Exhibit A

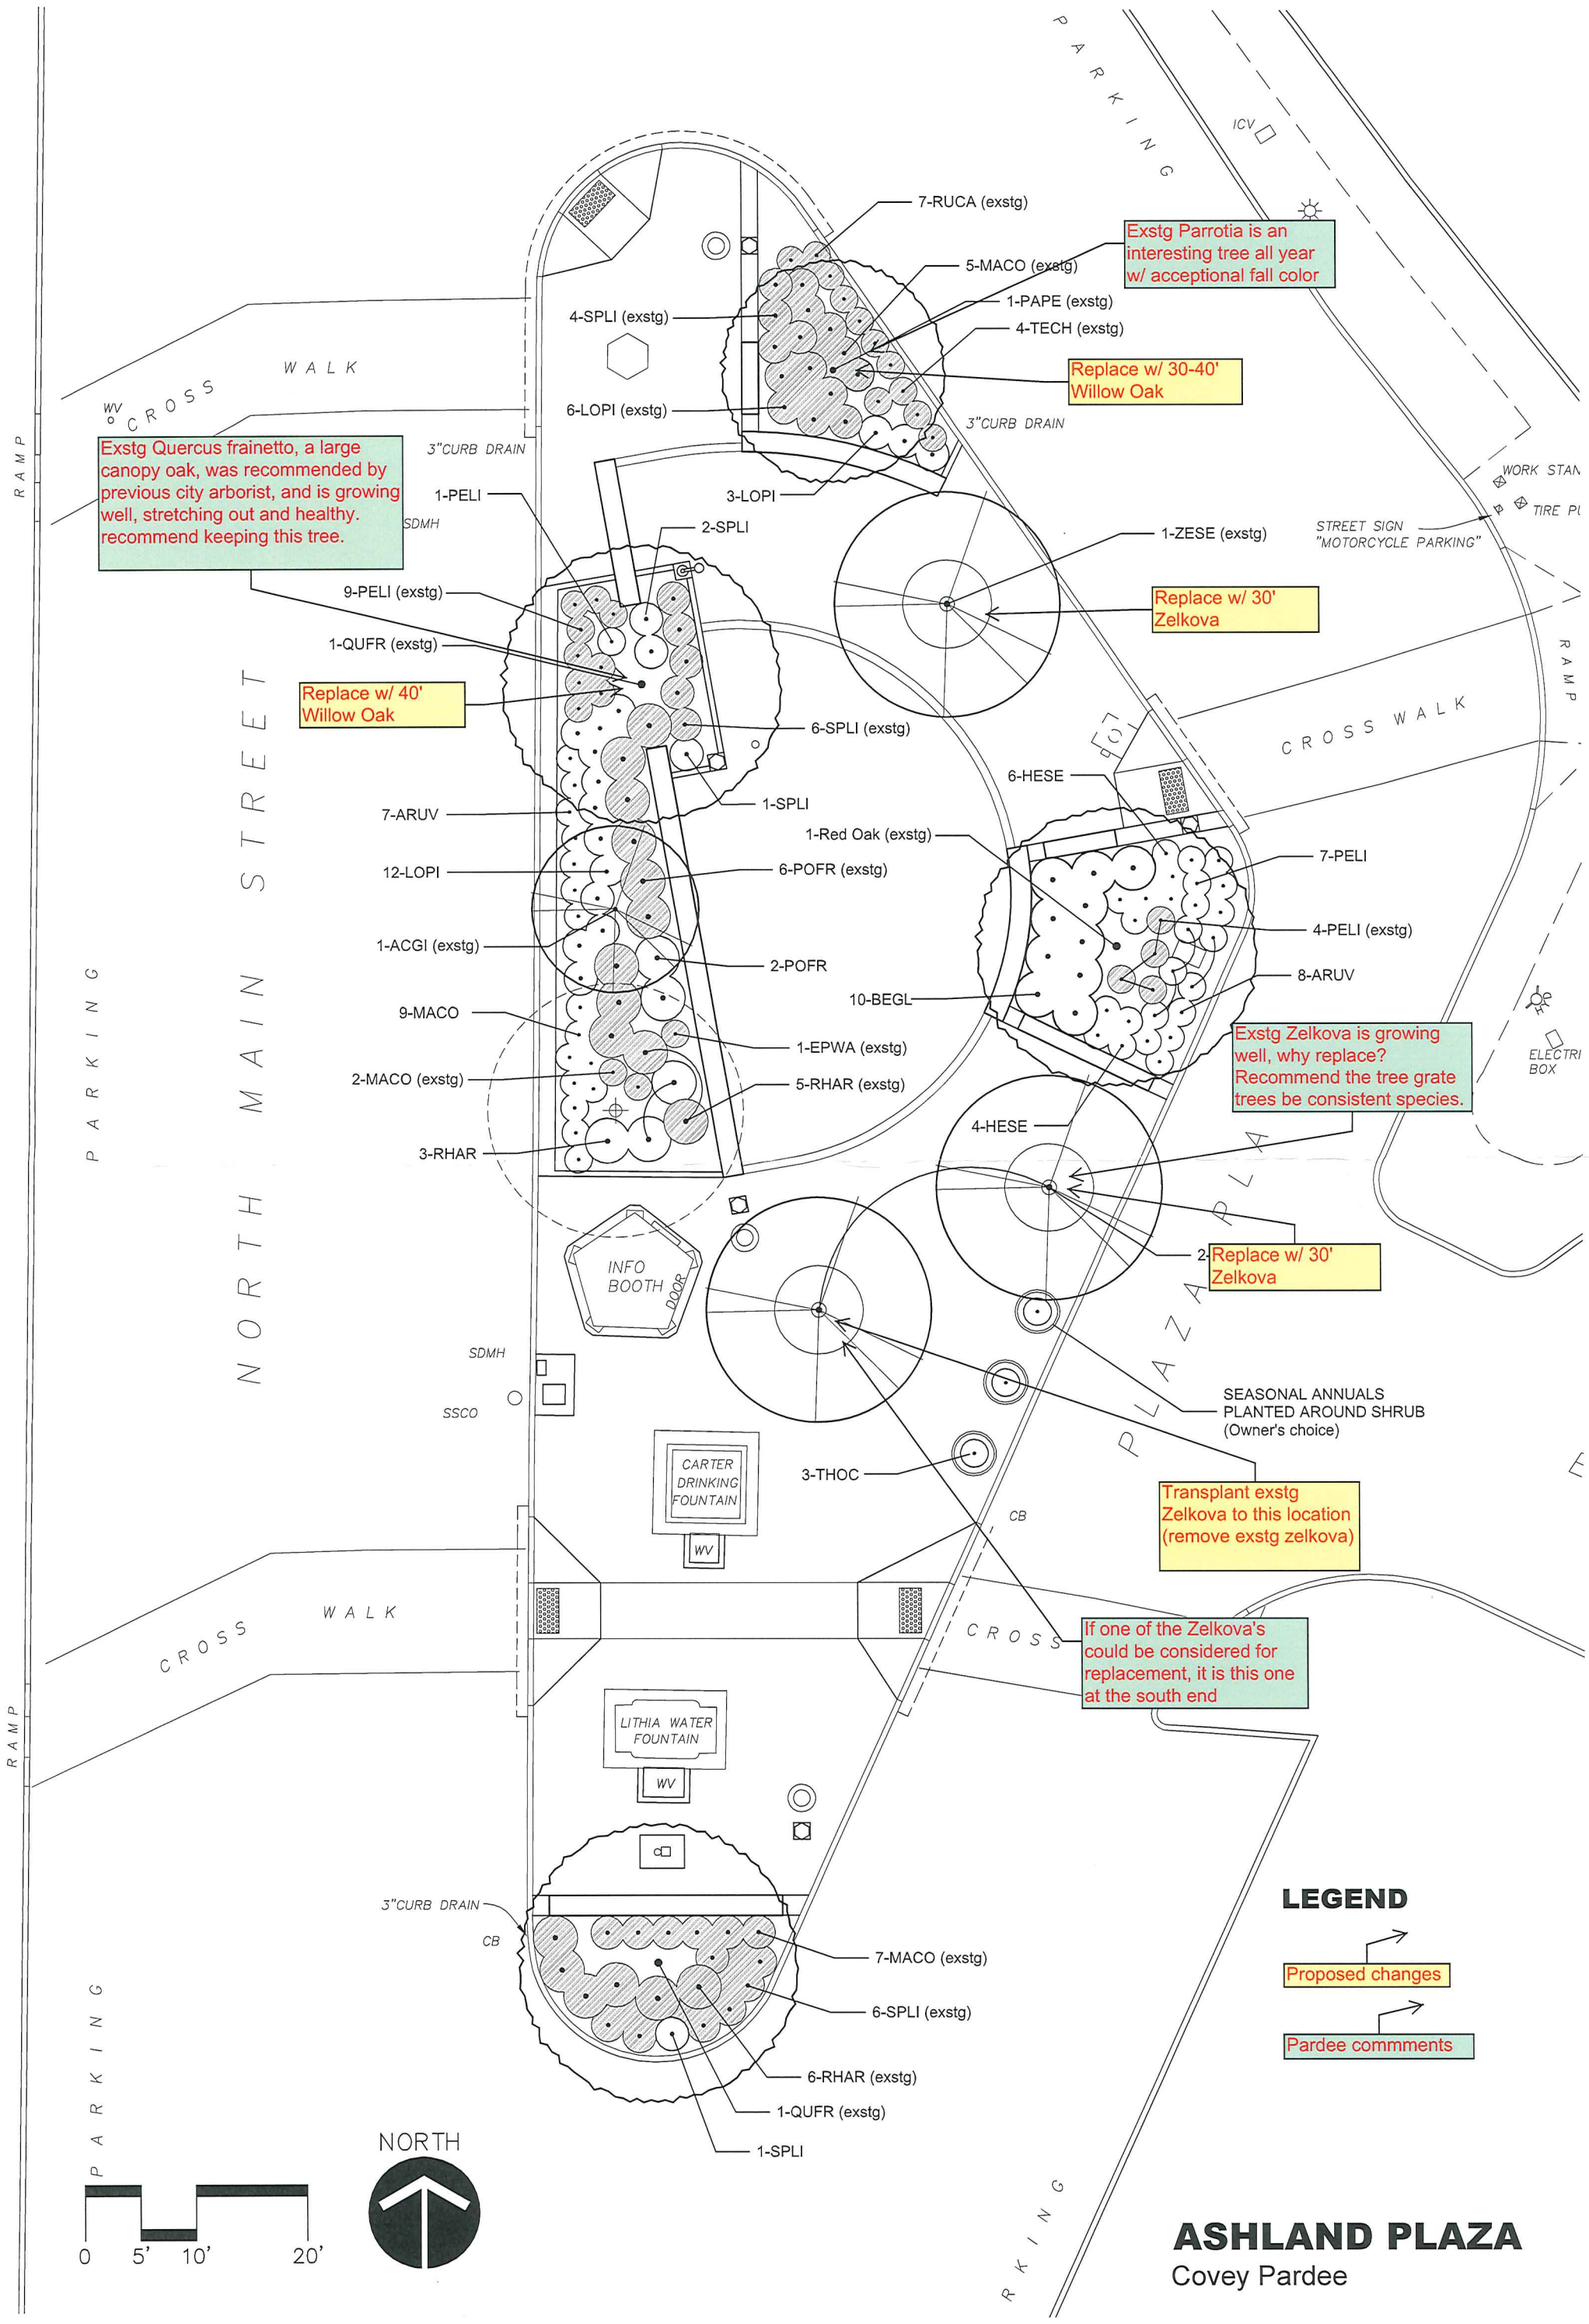
NORTH MAIN STREET
PARKING
CROSS WALK
RAMP
PLAZA DRIVE
7-RUCA (exstg)
5-MACO (exstg)
1-PAPE (exstg)
4-TECH (exstg)
4-SPLI (exstg)
6-LOPI (exstg)
3-LOPI
Exstg Parrotia is an interesting tree all year w/ acceptional fall color
Replace w/ 30-40' Willow Oak
Exstg Quercus frainetto, a large canopy oak, was recommended by previous city arborist, and is growing well, stretching out and healthy. recommend keeping this tree.
3"CURB DRAIN
1-PELI
2-SPLI
9-PELI (exstg)
1-QUFR (exstg)
Replace w/ 40' Willow Oak
6-SPLI (exstg)
1-SPLI
7-ARUV
12-LOPI
6-POFR (exstg)
1-ACGI (exstg)
2-POFR
9-MACO
1-EPWA (exstg)
2-MACO (exstg)
5-RHAR (exstg)
3-RHAR
1-ZESE (exstg)
Replace w/ 30' Zelkova
STREET SIGN "MOTORCYCLE PARKING"
WORK STAN
TIRE PU
6-HESE
1-Red Oak (exstg)
7-PELI
4-PELI (exstg)
8-ARUV
10-BEGL
Exstg Zelkova is growing well, why replace? Recommend the tree grate trees be consistent species.
ELECTRI BOX
4-HESE
2-
Replace w/ 30' Zelkova
INFO BOOTH
DOOR
SDMH

SSCO
SEASONAL ANNUALS PLANTED AROUND SHRUB (Owner's choice)
CARTER DRINKING FOUNTAIN
WV
3-THOC
CB
Transplant exstg Zelkova to this location (remove exstg zelkova)
If one of the Zelkova's could be considered for replacement, it is this one at the south end
LITHIA WATER FOUNTAIN
3"CURB DRAIN
7-MACO (exstg)
6-SPLI (exstg)
6-RHAR (exstg)
1-QUFR (exstg)
1-SPLI
LEGEND
Proposed changes
Pardee commments
NORTH
0 5' 10' 20'
ASHLAND PLAZA
Covey Pardee
